## SUMMARY OF CONCERNS IN RELATION TO THE PROPOSED NORTHCONNEX TUNNEL

**This is an objection to many aspects of the proposed NorthConnex tunnel.**

## SECTION A: THE CONNECTIVITY OF NORTHCONNEX SOUTHERN VENTILATION FACILITY AT THE SOUTHERN INTERCHANGE, THE SOUTHBOUND TUNNEL IN PARTICULAR

Figure 5-17 Motorway operations complex

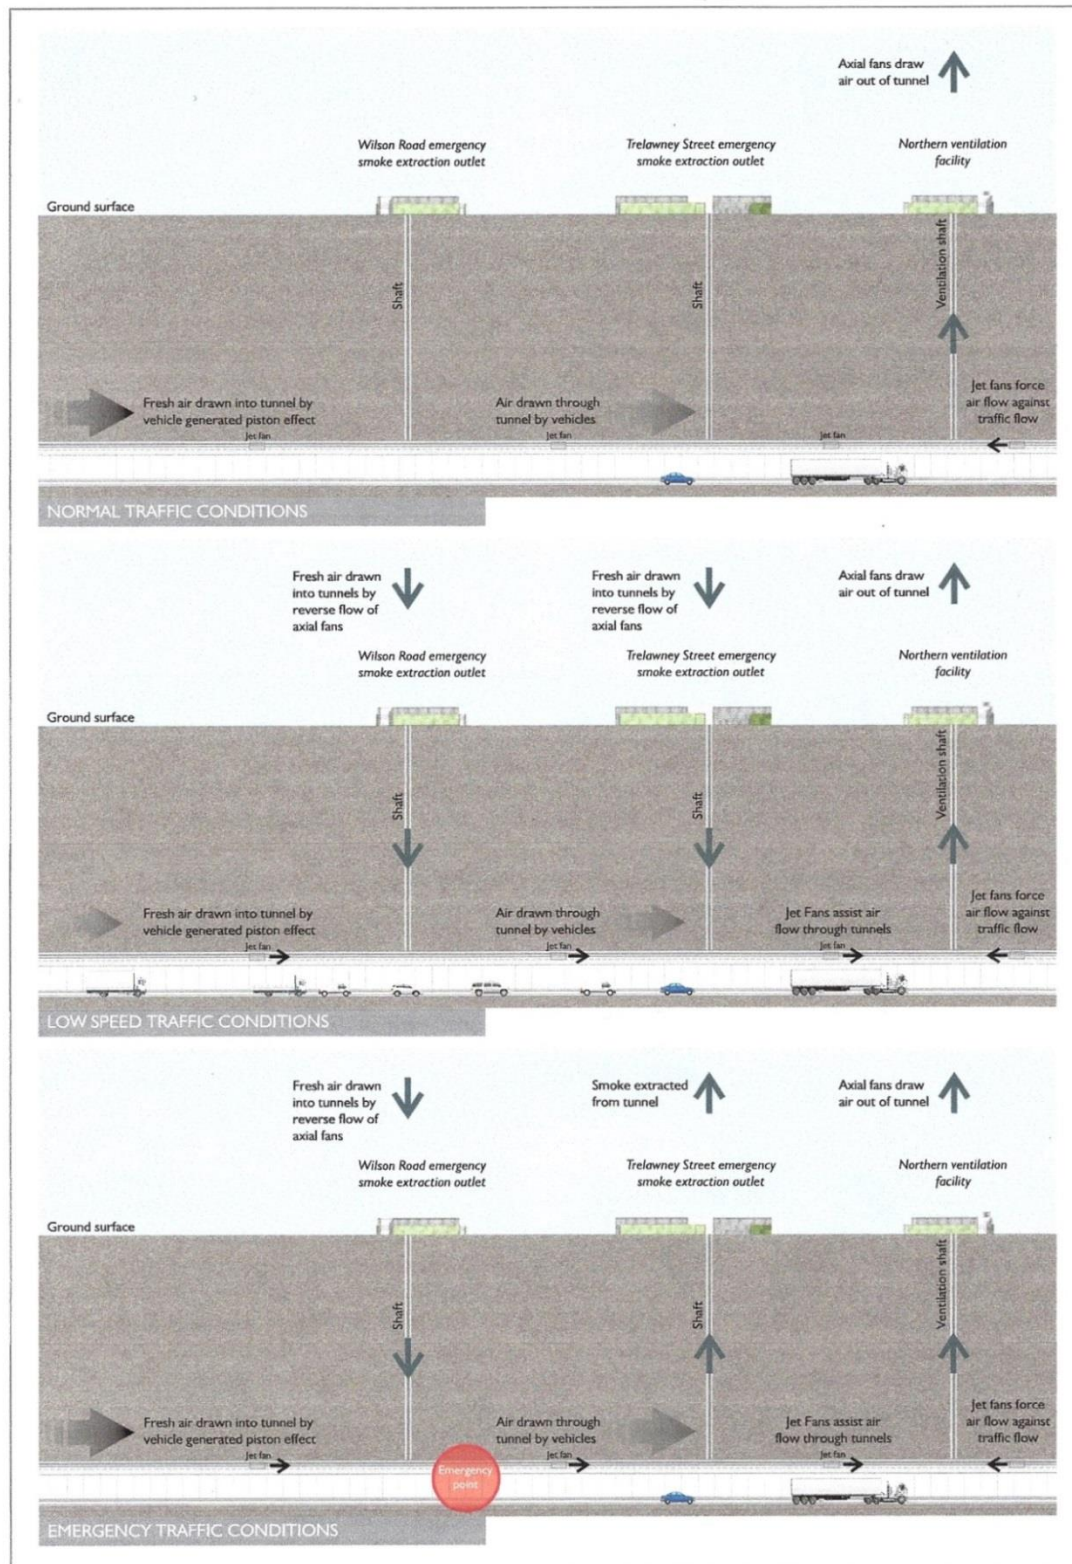
EIS Page 111, *Figure 5-17 Motorway operations complex*

*Page 8 below* there is no indication of how the ventilation facility will be connected to either the northbound or southbound tunnel, nor is there any indication of how the southbound exit portal onto Pennant Hills Road or the south-west exit portal onto the M2 will be connected.

- Diagrams need to be provided showing the inter-relation between the shaft, the ventilation outlet and the motorway operations centre with a clear description of what is to be constructed and how it will operate.
- The community needs irrefutable evidence that the polluted air from the southbound tunnel exit portals will not be allowed to flow like an invisible sewer through West Pennant Hills, North Rocks, Carlingford and Beecroft.

Figure 5-38 Indicative southern interchange construction compound

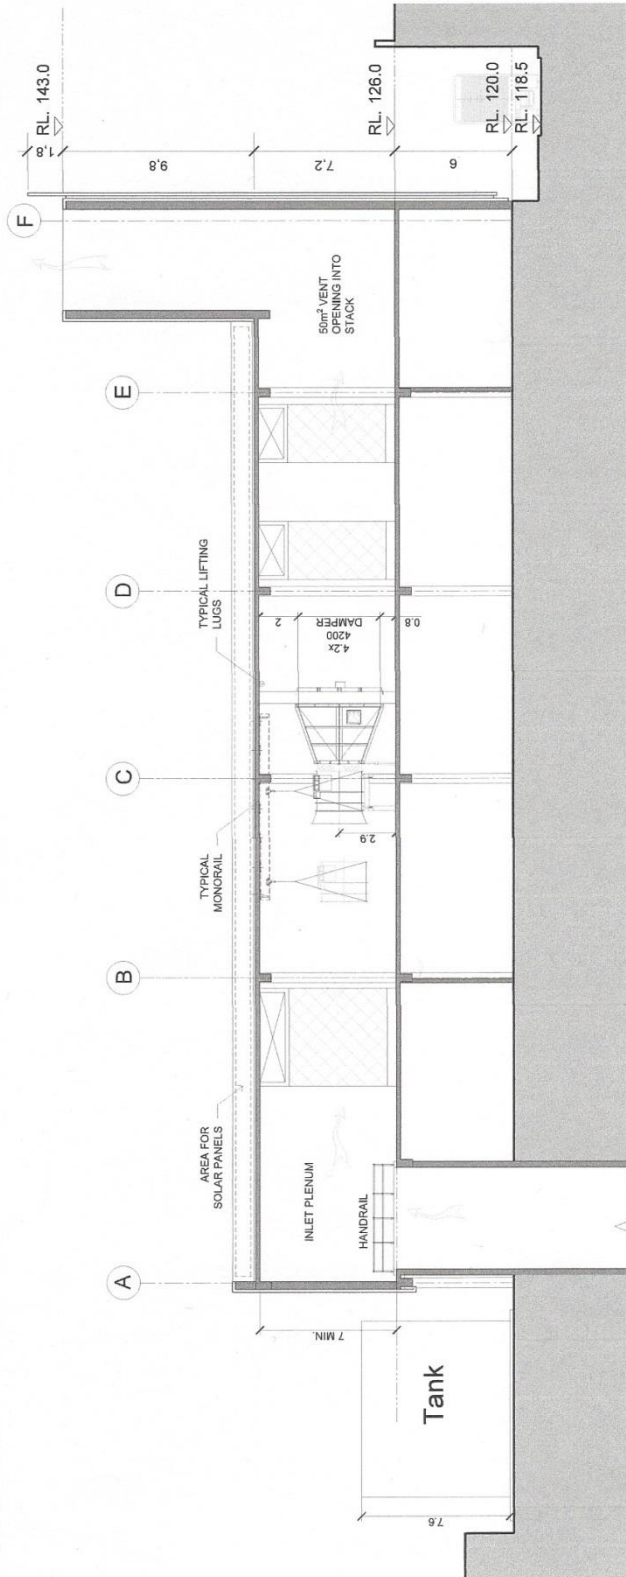
3. EIS Page 189 *Figure 5-38 Indicative southern interchange construction compound* *Page 9 below*

It is ominous that the southern ventilation facility and shaft are completely absent from Figure 5-38.

MOTORWAY OPERATIONS COMPLEX - SOUTHERN VENTILATION FACILITY - SECTIONS  
M1-M2-5000-DR-JD-0525

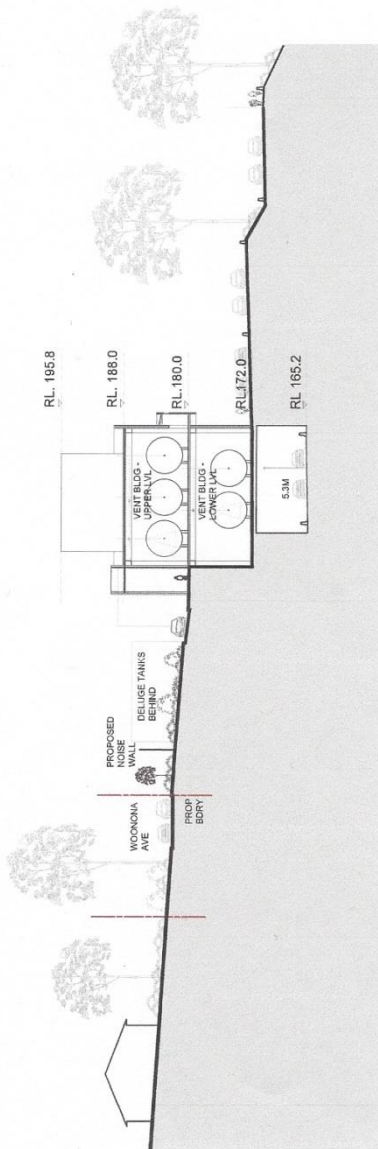
5. *EIS Volume 4, Technical working papers - Urban Design, 6.0 Operational Ancillary Facilities*  
EIS Page 99 there is the diagram "Motorway Operations Complex – Southern Ventilation Facility – sections. *Page 10 below* The diagram has the cryptic label "Connection to tunnel TBC". What does TBC stand for? To be considered? Why is tunnel singular? Which tunnel is the diagram referring to northbound or southbound? There is no diagram showing any connection from the Southern Interchange ventilation facility to either the northbound or the southbound tunnel in any way AND YET ....

MOTORWAY OPERATIONS COMPLEX - SOUTHERN VENTILATION FACILITY - SITE SECTION 1-1  
M1-M2-5000-DR-UD-0713

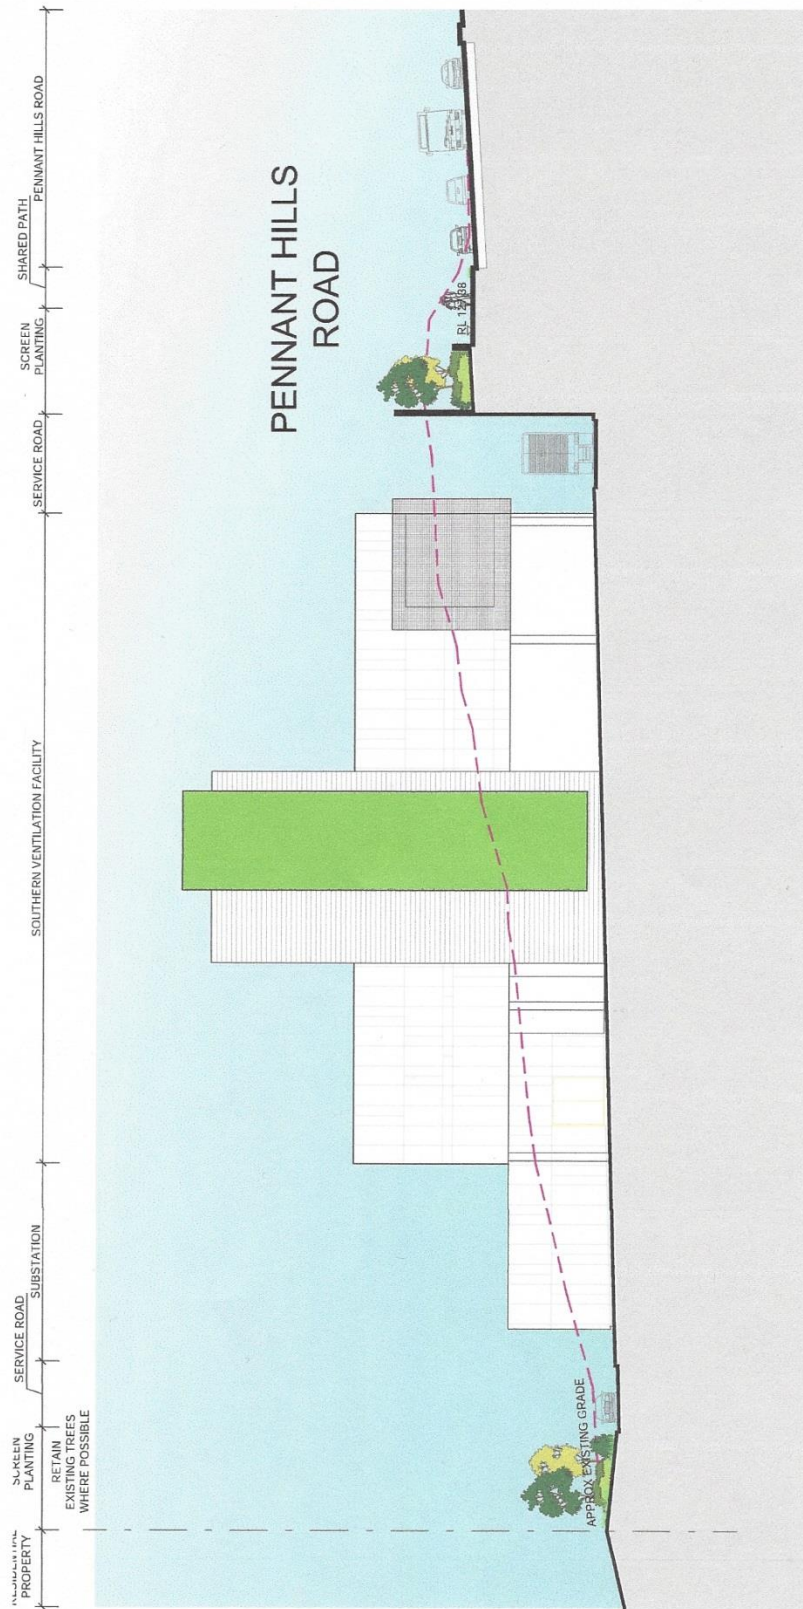
6. *EIS Volume 4, Technical working papers Urban Design, 8.0 Landscape Design*  
EIS Page 176 is the diagram "Motorway Operations Complex – Southern Ventilation Facility – Site 1-1". *Page 13 below* The diagram does not show any connection to either the northbound or southbound tunnel. In the same Landscape Design section, EIS Page 182 is the diagram "Wilson Road Tunnel Support Facility –Section" *Page 14 below* which clearly shows the connection to the tunnels. In the same Landscape Design section, EIS Page 189 is the diagram "Northern Ventilation Facility – Landscape Concept Section". *Page 15 below* This also clearly shows the connection to the tunnels.
